**NORTH AMERICAN—REWORK OF COOLANT LINES—P-51B, P-51C,  
AND P-51D**

2. The instructions for accomplishing this modification as contained in North American Service Bulletin SB/P-51-197, dated 25 September 1944, are as follows:

RESTRICTED  
T. O. No. 01-60J-36

Figure 1 - View Looking Forward at Fire Wall From Left Wheel Well

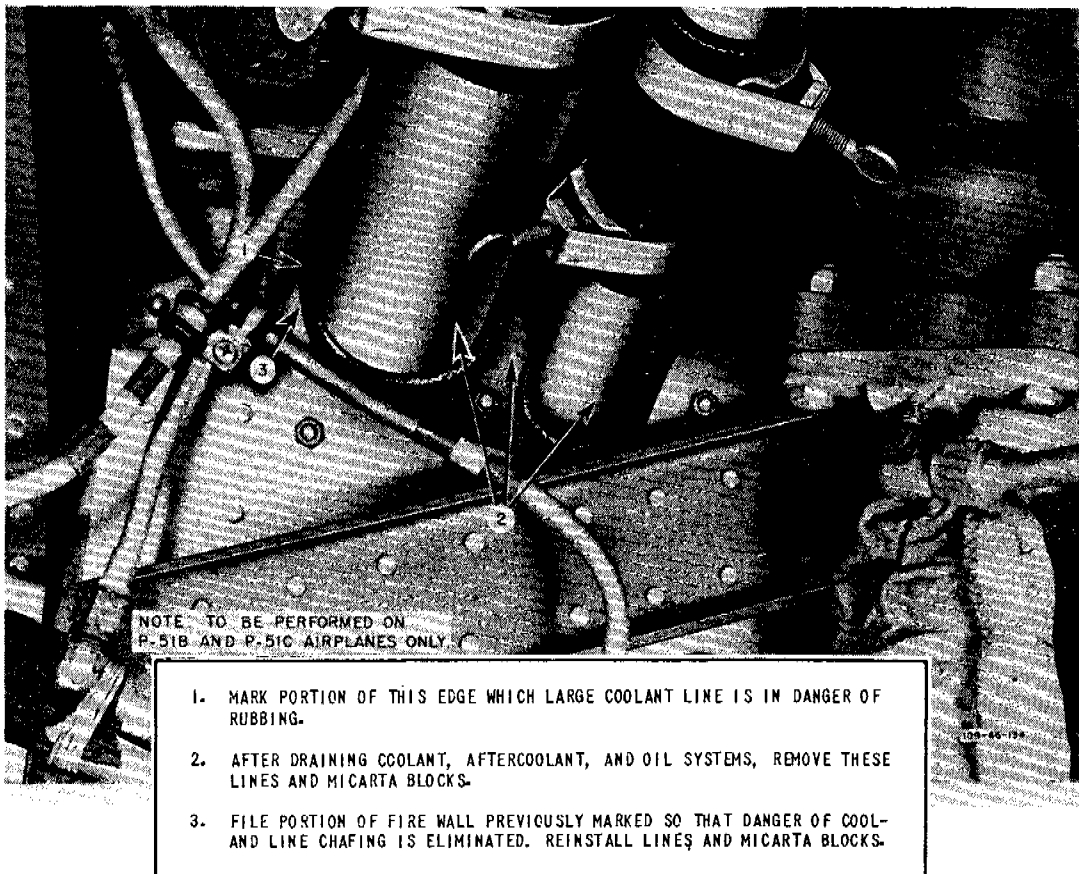
c. Locate the area on the fire wall which is in danger of chafing the large coolant line, part No. 102-46814, and mark this area with a pencil. (See figure 1.)

e. Using a half-round file, cut away that portion of the fire wall previously marked to insure that sufficient clearance exists between fire wall and coolant line.

Figure 2 - View Looking Forward at Fire Wall From Right Wheel Well

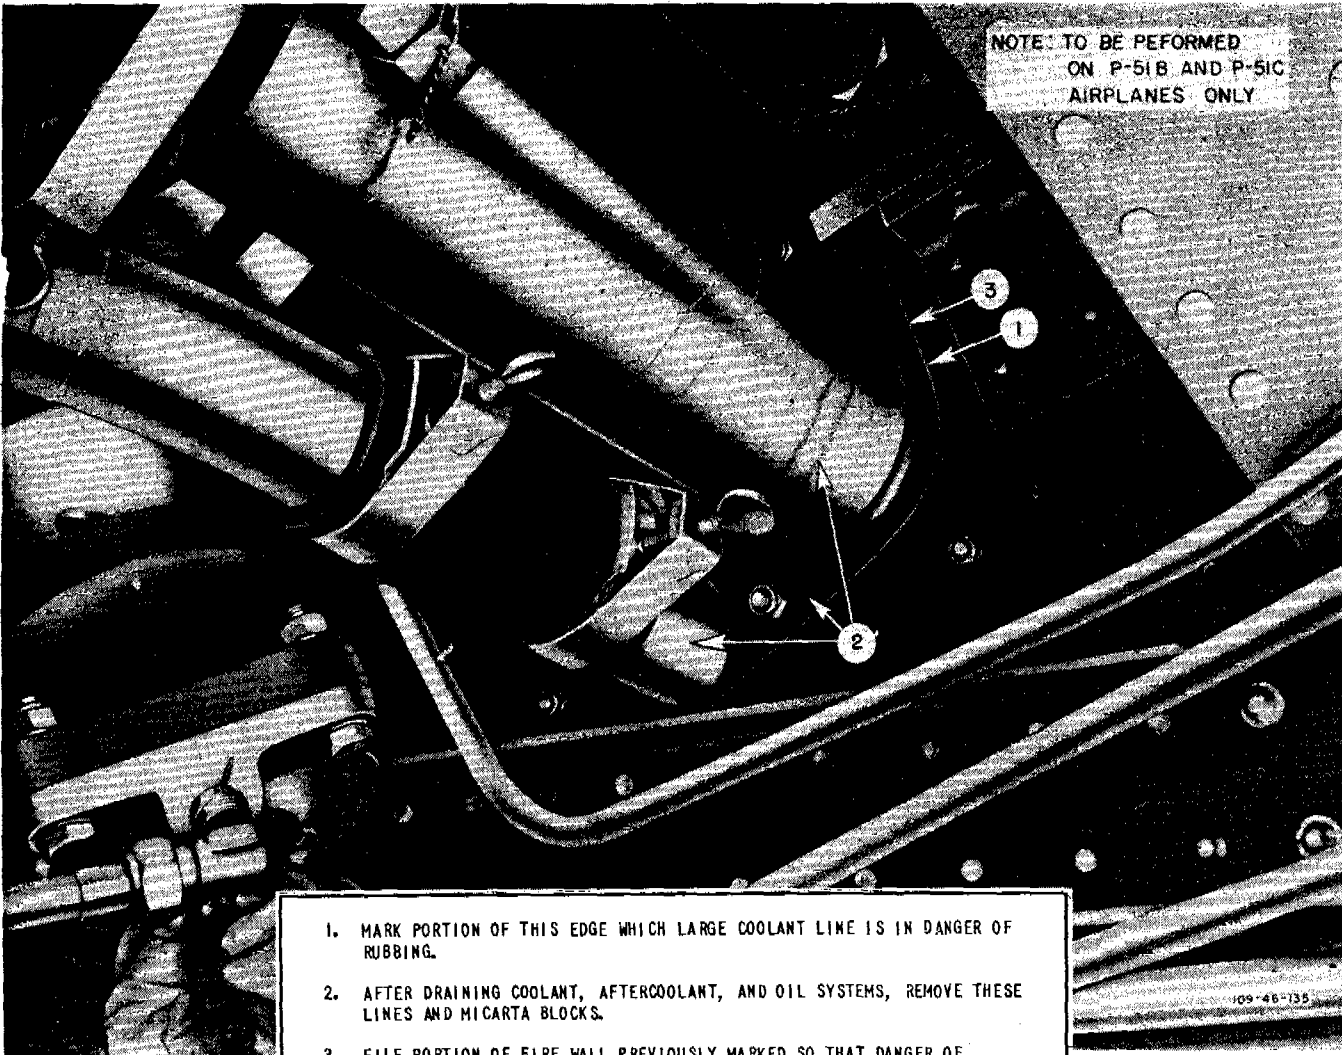
g. Locate the area on the fire wall which is in danger of chafing the large coolant line, part No. 102-46816, and mark this area with a pencil. (See figure 2.)

i. File the section of fire wall previously marked as directed in paragraph 2.e.

Figure 3 - Rework of Coolant Line Indentation on Filter Section of Carburetor Air Scoop - Looking Forward

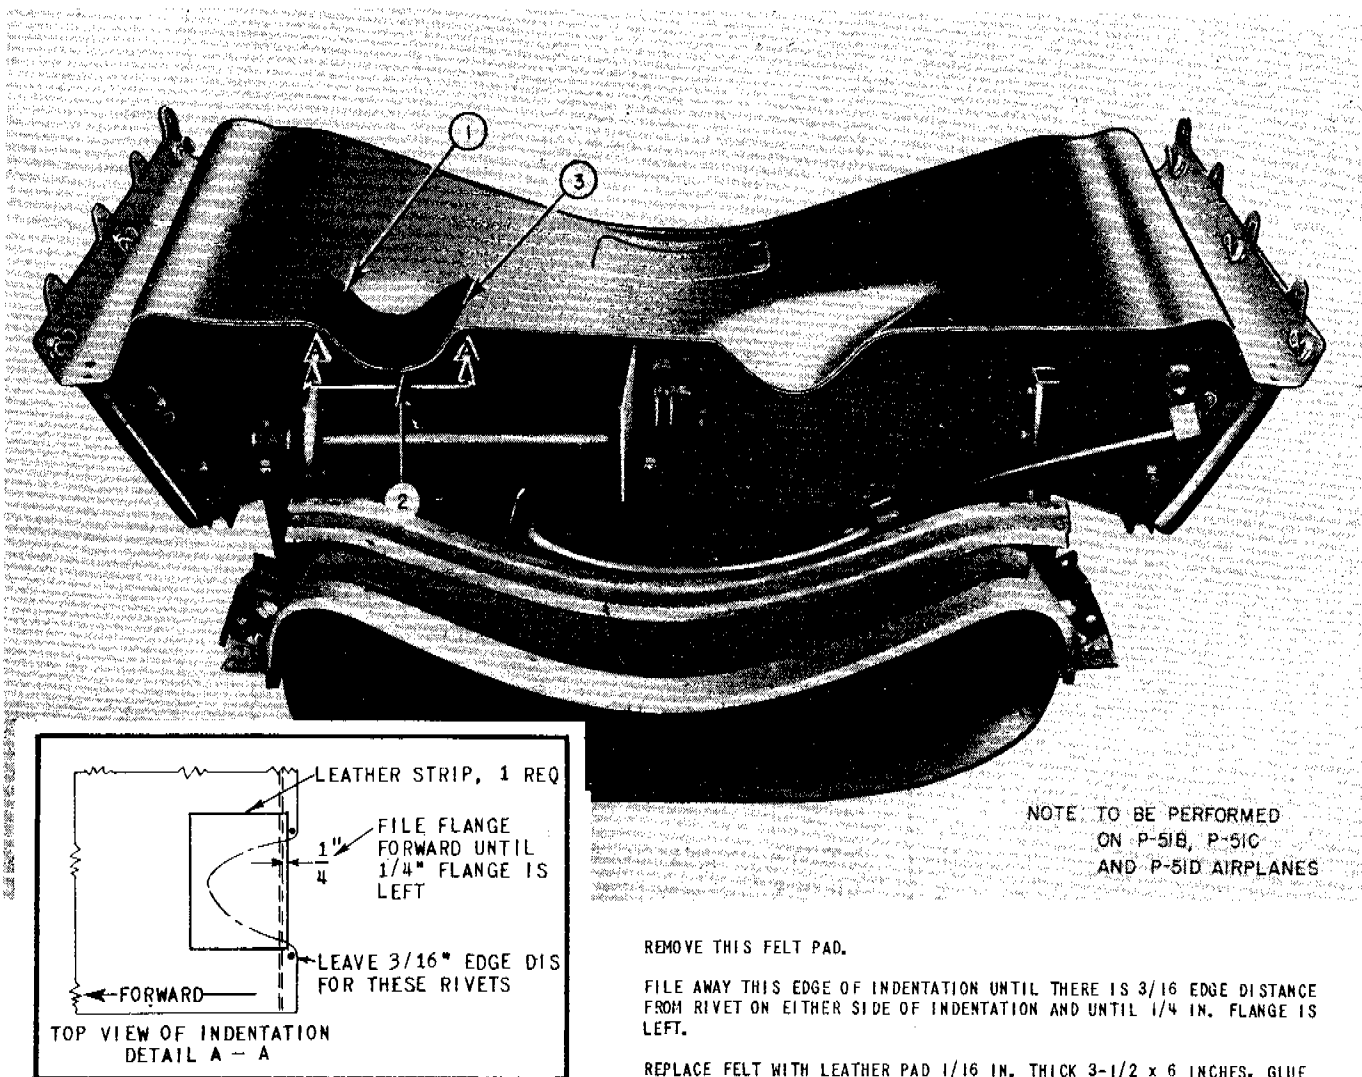
o. After locating the indentation for the coolant line on the left rear portion of the carburetor air scoop filter, remove the felt pad and file the edge of the indentation forward until there is 3/16-inch clearance for the existing rivets and a minimum 1/4-inch flange remains. (See figure 3.)

p. Replace the felt pad with a similar piece of leather 1/16-inch thickness and glue in place.
